**REPORT ON
INDEPENDENT ANALYSIS
AND ADVICE REGARDING
THE SAFETY CASE 2015**

Tihange 2
**Reactor Pressure Vessel
Assessment**

V1 03 November 2015 •

Electrabel
GDF SUEZ

Figure 1: Evolution of the rejection thresholds between 2012 and 2014

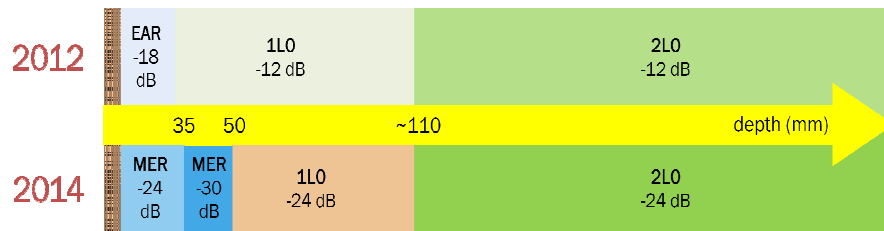
The SCP Review Team pointed out that the rejection threshold has to be selected in such a way that a high confidence level would be ensured for the detection, regardless of the effect of the faceting or other geometrical elements. The SCP Review Team requested that a confidence level of 95% should be reached corresponding to the best practices in that domain.

The SCP Review Team questioned the Project Team regarding the selection of the sensor used to perform the UT examination of the first mm of the core vessel, just behind the cladding. Two sensors could have been used: one MER and one EAR.

The final consolidated results of the qualification confirmed that the MER sensor provided a level of performance similar to the EAR but that its response was better at near depths inside the material (especially <30 mm). At higher depths, the rejection threshold has been lowered to maintain the detection capability.

To illustrate the selection of the rejection threshold and the use of the sensors, Figure 1 shows clearly the old and new values used.

Figure 5: Indication size distributions (UCS: Upper Core Shell) based on the 2012 or 2014 methodology with the 2012 raw data

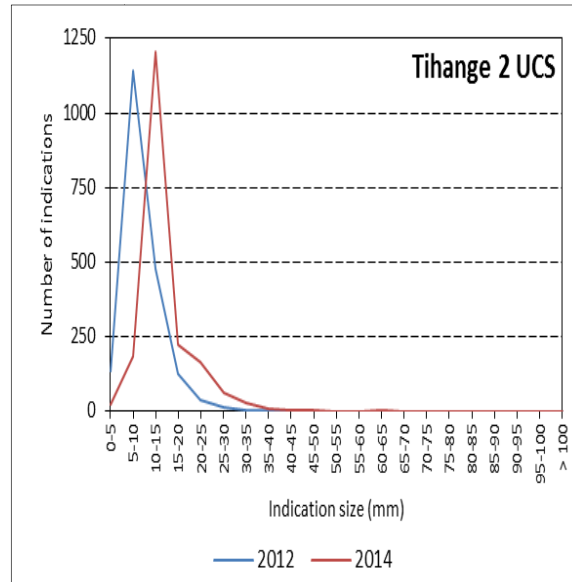
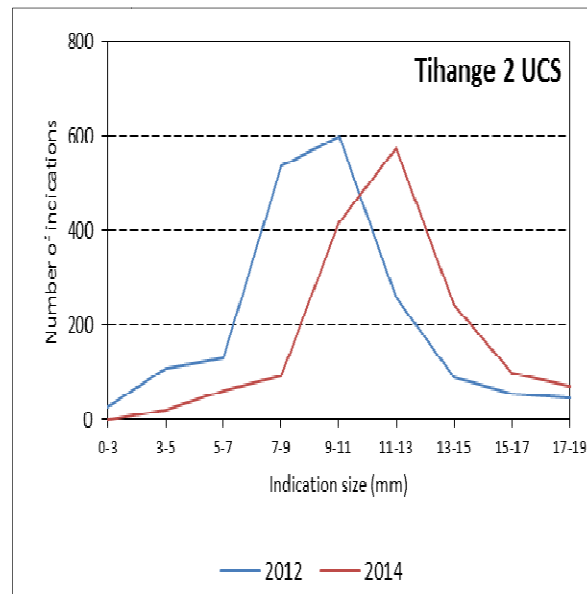
Since the continuous improvement of the qualification led to a new rejection threshold in the 2014 methodology, the SCP Review Team requested that the Project Team re-analyse the 2012 raw data set using the 2014 methodology (the echo-dynamic sizing), in addition to the analysis already performed with the 2012 methodology (the historical 6 dB drop sizing). On one hand, this action aimed at demonstrating that no evolution of the indications occurred between the inspection of 2012 and the inspection of 2014. On the other hand, it enabled establishing a better reference point (2012 inspection) for the comparison with any potential further examinations.

In answer to this request, the Project Team provided improved statistics summarized in Table 4 and illustrated in figures 5 and 6.

Figure 8: Distribution of the number of indications with respect to the depth—VB395/2A

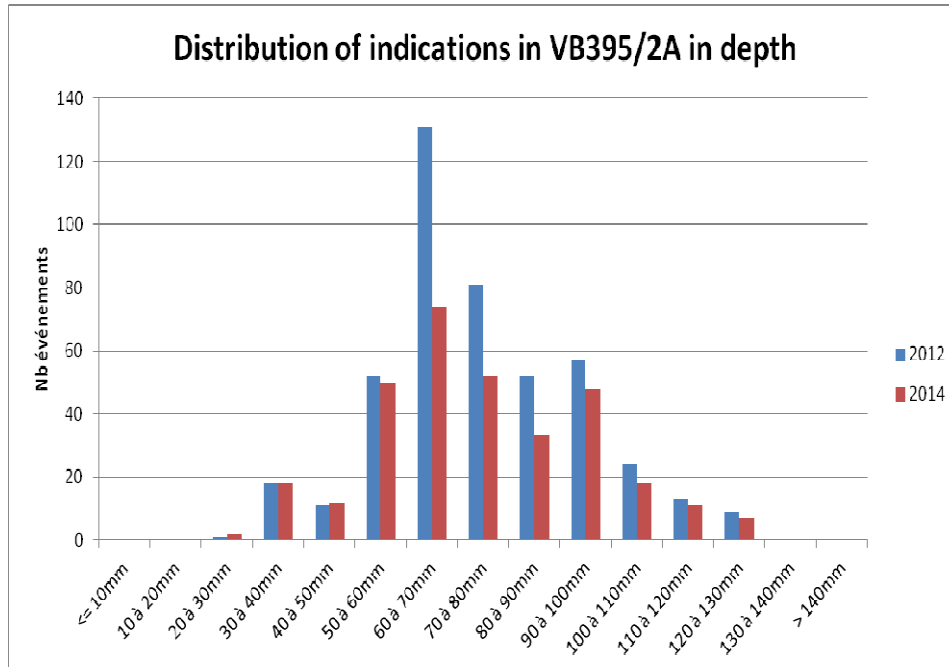
After the presentation of those results, the FANC requested complementary information aiming at clarifying whether the same exercise of reanalysis with the 2014 methodology was done on the VB395/2A block used for the qualification and on which measurements were performed in 2012.

The reanalysis revealed that the same behaviour was observed on the VB395/2A block: a reduction of the number of indications but an increase in size (Figure 8, Table 9)¹.

Figure 10: Normalized histogram of the delta in DZ sizing (usual sizing—alternative sizing)

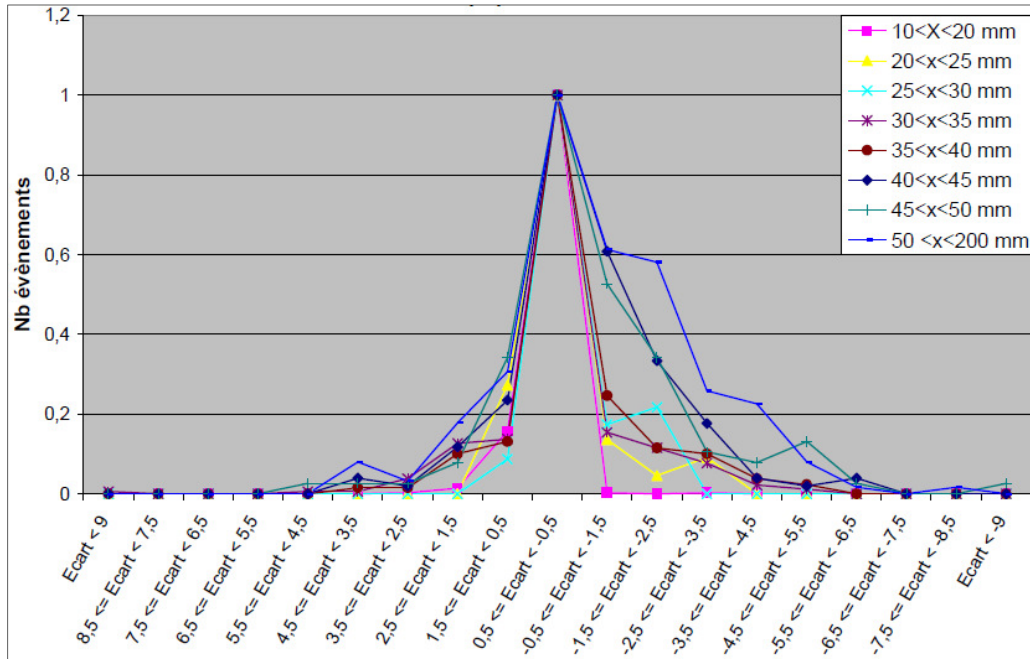
In order to challenge this conclusion, AIA requested that complementary comparisons between the two methodologies be performed, with no destructive test, on the lower shell of the Doel 3 RPV. The following comparisons have been performed:

It appears that the results are equivalent up to 20 mm. For the largest indications, it can also be concluded that the 'alternative' methodology gives statistically larger dimensions in DZ.

The Project Team performed a sensitivity study on the SIA with DZ inputs from the 'alternative' method for indications larger than 20mm in the DX or DY dimension (see § 4.6). As far as this sensitivity study shows that the SIA is not impacted, the SCP Review Team considers that the original 6 dB drop sizing methodology can be maintained for Z coordinates.

Figure 16: $K_{I,max}$ values compared to lower shelf toughness for flaws close to the cladding-base metal interface

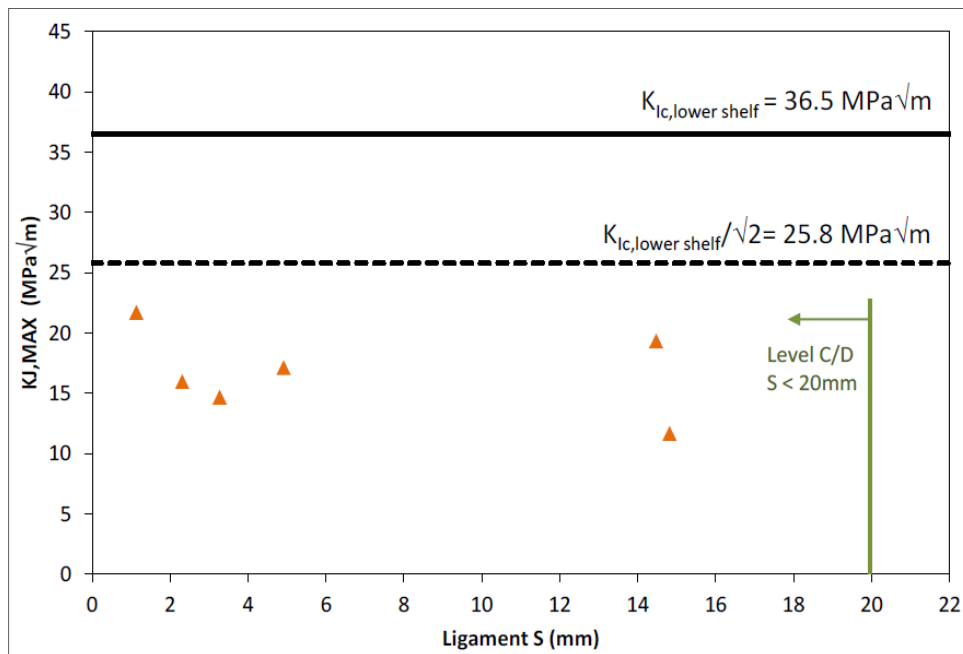
“Provide an assessment of the severity of the upgraded degraded condition of the Doel 3 and Tihange 2 RPVs by comparison to the condition assumed in the 2012 Safety Cases (estimation of the distribution of the driving force $K_{applied}$)”

It can be seen in Figure 16 that there is no point above the lower shelf divided by the safety factor in the first 20 mm of the reactor pressure wall.
